Access Compliance Report

Public Rights-of-Way

(Curb Ramps)

Intersection ID: 13422	Main Street: E_W_T_HARRIS_BV	Cross Street: TRYSTING_RD	Location: SE
ADA ID: D6687EB6D29B	Ramp Type: PerpDiag	Initial Pass/Fail: Fail	Overall Compliance: No
Severity Score: 22.5			
Codes/Mitigation Info/Possible Solution		Field Measurements/Component Compliance

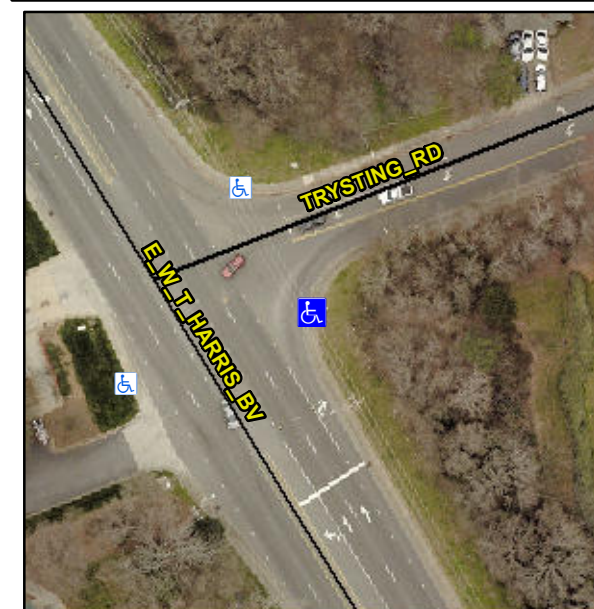
Not Found, R304.5.1, R304.2.2, R304.5.3

Compliance	Description	Data	Compliance	Description	Data
N/A	Ramp Length (in)	61.0	No	Ramp Slope (%)	8.9
No	Ramp Width (in)	47.0	No	Ramp XSlope (%)	2.4
N/A	Flare Type LT	N/A	N/A	Flare Type RT	N/A
N/A	Flare Slope LT (%)	N/A	N/A	Flare Slope RT (%)	N/A
N/A	Flare Traversable LT?	N/A	N/A	Flare Traversable RT?	N/A
N/A	Landing Length (in)	N/A	N/A	DWS Provided?	N/A
N/A	Landing Width (in)	N/A	N/A	DWS Contrast?	N/A
N/A	Landing Slope (%)	N/A	N/A	DWS Length (in)	N/A
N/A	Landing X Slope (%)	N/A	N/A	DWS Full Width?	N/A
N/A	Landing Curb? (Y/N)	N/A	N/A	DWS Offset (in)	N/A
N/A	Shared Landing?	N/A			
N/A	Gutter Ponding?	N/A	N/A	Gutter Slope (%)	N/A
N/A	Gutter Lip Ht (in)	N/A	N/A	Gutter X Slope (%)	N/A
N/A	Painted X Walk1?	No	N/A	Painted X Walk2?	No
	X Walk 1 Direction	To N		X Walk 2 Direction	To W
N/A	X Walk 1 Width (in)	N/A	N/A	X Walk 2 Width (in)	N/A
	X Walk 1 Slope (%)	0.2		X Walk 2 Slope (%)	2.9
	X Walk 1 X Slope (%)	1.9		X Walk 2 X Slope (%)	0.3

Remove & Replace Curb Ramp With Two New Directional Ramps or Equivalent.
